Hampton Quay - River Arun

Site Visit Summary Document

Carcinus Reference: J0553_190701

Date: 04 November 2019

Figure 18 -- Initial Proposal

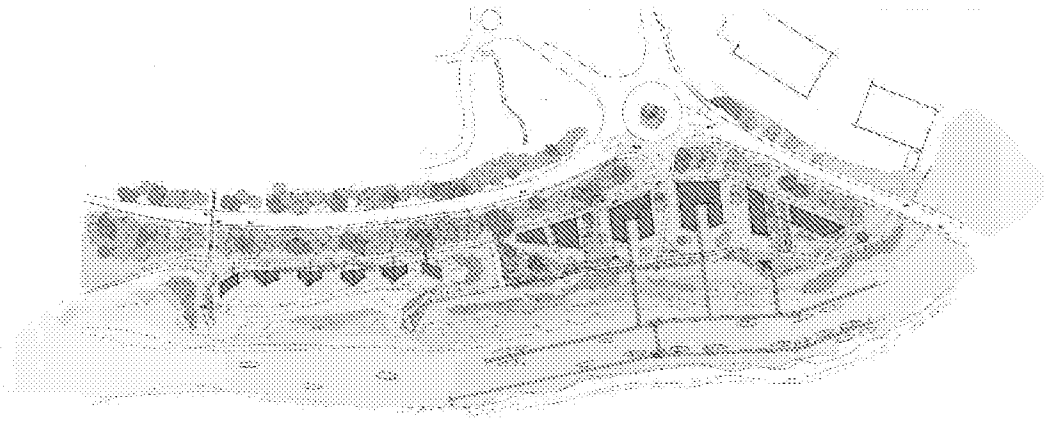
Please see figure 18 for sketch of initial proposal provided to Carcinus to review.

The creation of a lagoon would necessitate diversion of one of the freshwater channels and retention of freshwater inflow. The result will be reduced salinity potentially encouraging development of a lagoon system. It is, however, felt this is unlikely due to the high salinity of the adjacent Arun, plus development of lagoon conditions will exclude saltmarsh species on the healthy developing marsh which require almost full salinity. Further to this, lagoon conditions, if developed, may result in colonisation by rare species which would subsequently require specific management to ensure a healthy population is maintained.

There is also some concern that restriction of flow and loss of the marsh with standing waters may lead to a stagnant water body with subsequent unpleasant odour. This effect has been noted in other man-made harbour systems where water circulation is reduced.

Overall, the creation of a lagoon is not recommended for the points noted above. The Arun is not a natural lagoon development area at this site (lagoons usually require almost full isolation from marine habitat with some seepage / small marine input) and whilst a worthy aspiration it is felt that significant detrimental ecological and potentially costly effects may result.

Comments with regards to floating or stilted structures in the lagoon, and boardwalk access over the marsh. Pontoons and stilted structures have the potential to create shade which will exclude photosynthesis. Designs should allow natural light should such plans be taken forward, however, note that shade and vessels associated with pontoons will result in marsh loss due to vessel settling, wash, and light loss. It is understandable that this is an aspiration for the site, however, it may have to be accepted that the developing marsh will not tolerate such impacts and may thus become fragmented; when and if this occurs, root material loss will result in loss of sediment through erosion (natural and vessel exacerbated).

Where shading may occur such as due to boardwalks, marsh die back due to lack of light is a common outcome plus this loses bird and fish foraging habitat (shade flight response) when the tide is in / out respectively. Should marsh flora die back occur, this will lead to loss of binding roots, and subsequent reduction in sediment material which will result in marsh erosion (feedback loop). Whilst the suggested board-walk may be at the upper edge of the marsh, saltmarsh relies on drainage channels for tidal inundation and saline water input (the plants are obligate halophytes). Therefore, for healthy marsh there will always be some water flow even at the upper marsh. Accordingly, erosion due to vegetation loss can be an issue even at high marsh levels.

The effects noted in above remain largely similar for the middle site. However, if pontoons could be developed so that vessels remain to some extent in main channel flow, with limited small vessel mooring / activity on the inner face, then marsh effects would be significantly limited as the main channel area tidal movement naturally prevents marsh development.

Walkway and bridge structures have the potential to create shade, inhibiting photosynthesis. Designs should allow natural light where possible. Where shading does occur, marsh loss is likely to occur to some degree and the marsh may thus become fragmented, exacerbating erosion.

Further to the shading comments, where piles are driven in, these should, where possible, avoid being in the marsh area. Piles can create local hydrodynamic change leading to small scale eddies and erosive forces during the tidal cycle. These localised enhanced hydrodynamic forces can re-suspend sediment potentially again undermining / eroding marsh and this can be an iterative process (further negative feedback loop) leading to further possible binding vegetation loss.

With regard to mooring, it is advised that larger vessels be restricted to the main channel rather than be allowed to moor on the landward side of the pontoons. This is specifically in relation to prop wash and bow thruster use which will create forces on the fine sediment exacerbating erosion forces. Further to this, larger vessels will have antifoul and other contaminants which can be detrimental to marsh health. Retaining them in the main channel area will allow a greater tidal flushing effect, though at all times the suggested environmental management plan should seek to minimise contaminants to the system.

- Remove the lagoon proposal;
- Omit the floating or stilted structures over the salt marsh;
- Re-locate moorings within main river channel;
- Limit small vessel mooring / activity on the inner face;
- Board-walks should be taken above terrestrial habitat rather than marsh / mudflat; and
- An environmental / habitat plan should be implemented during construction.

Figure 19 --- Pre-application Proposal

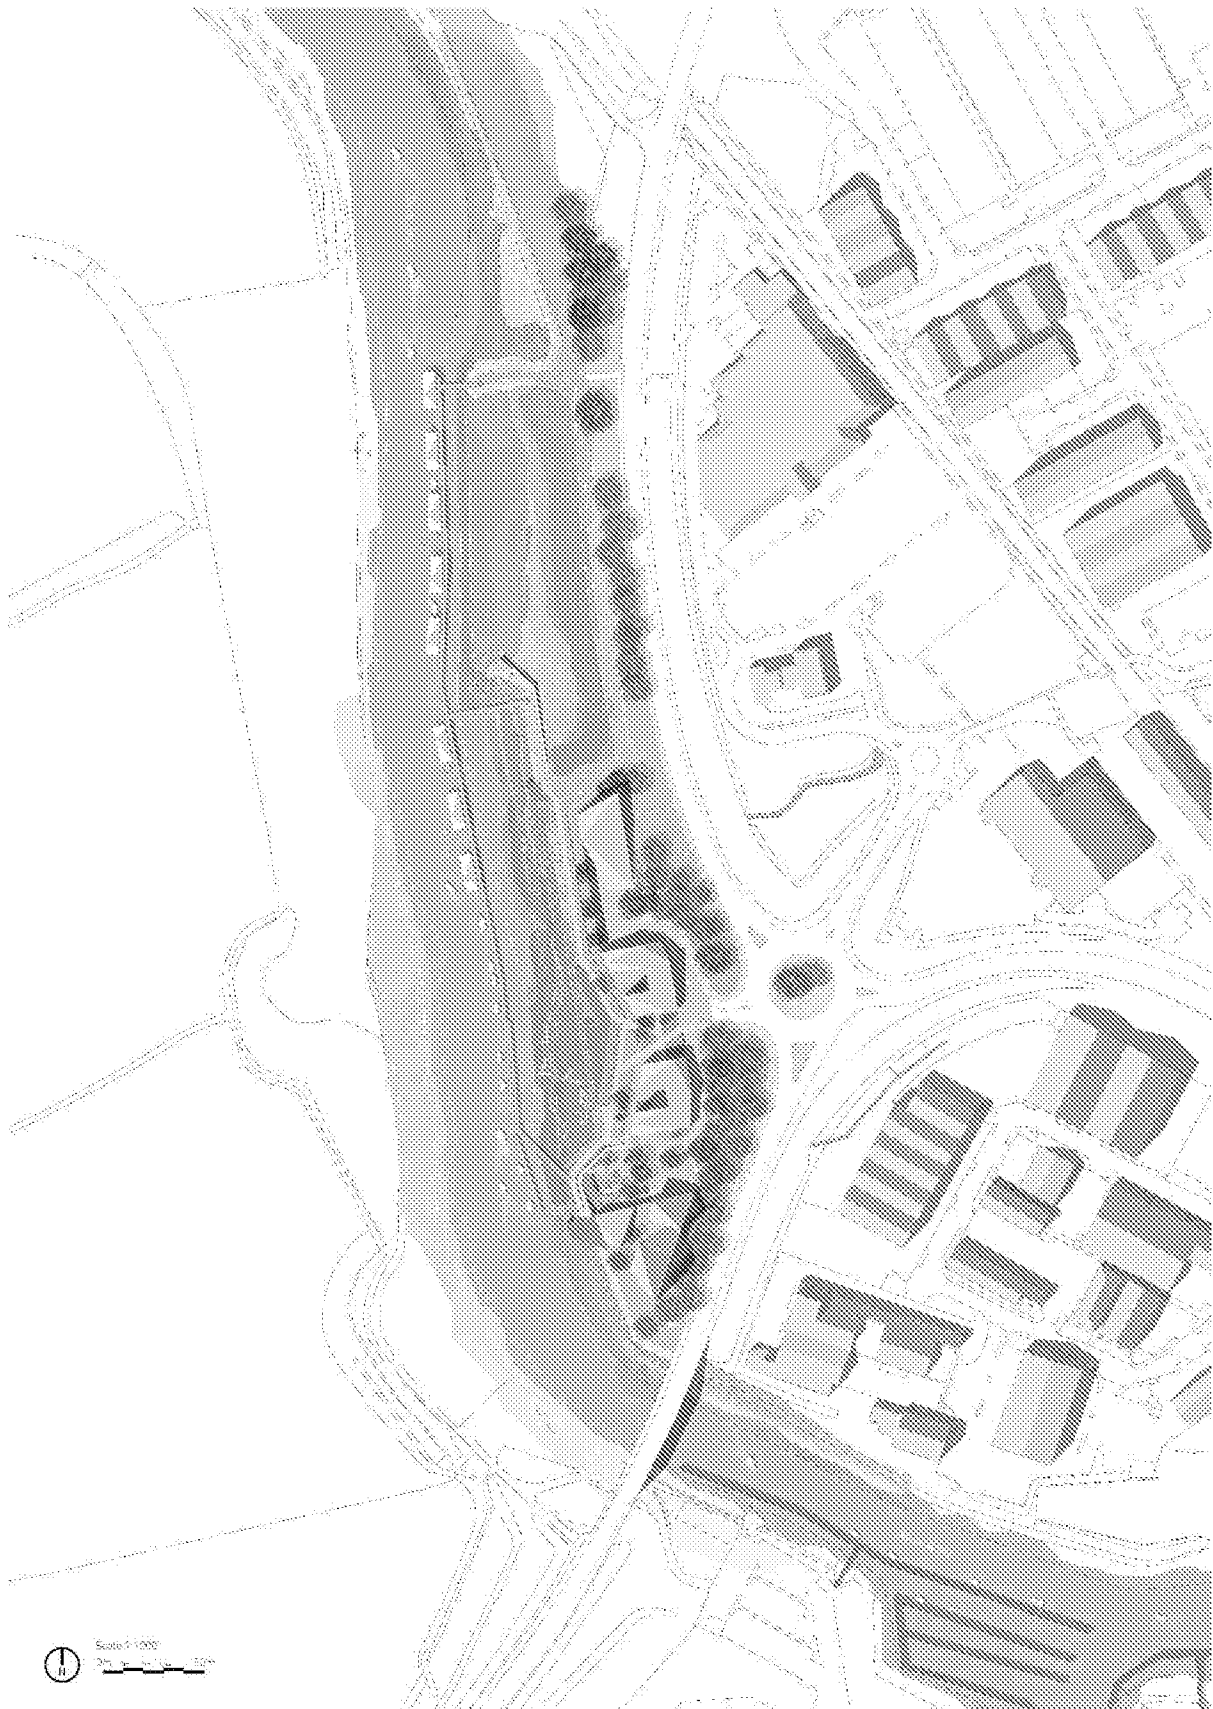
Following previous advice provided to Stolon Studio, Carcinus were appointed to provide further feedback on the pre-application proposal. Please see figure 19 for your reference.

- *Shifted the pontoons further into the main river channel allowing them to move up and down with the tide;*
- *Piles [are planned to] be located within the river bed therefore [avoiding] the marsh area;*
- *Moved the main points of access to the 'spits' to avoid shading over the saltmarsh; and*
- *Seeks to reduce existing erosion through the pontoon design. However, note that Carcinus and AQASS advised that a saltmarsh retention programme may be more effective.*
